# Access Compliance Report

## Public Rights-of-Way

### (Curb Ramps)

Intersection ID: 21388	Main Street: CHAMPAIGN_ST	Cross Street: WAREWHIP_LN	Location: NW
ADA ID: B6000284DD69	Ramp Type: PerpDiag	Initial Pass/Fail: Pass	Overall Compliance: No
Severity Score: 20			
Codes/Mitigation Info/Possible Solution		Field Measurements/Component Compliance

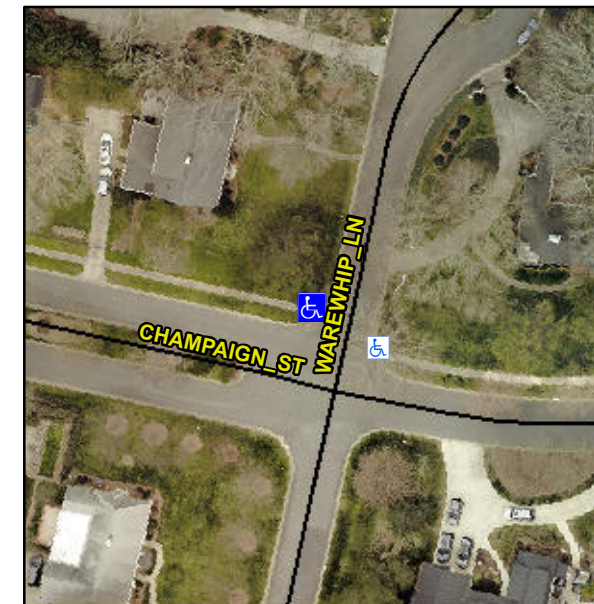
**Remove & Replace Curb Ramp With Two New Directional Ramps or Equivalent.**

**Not Found, R304.2.1, R304.2.2-Perp, R304.3.2-Para, R304.5.3, R305**
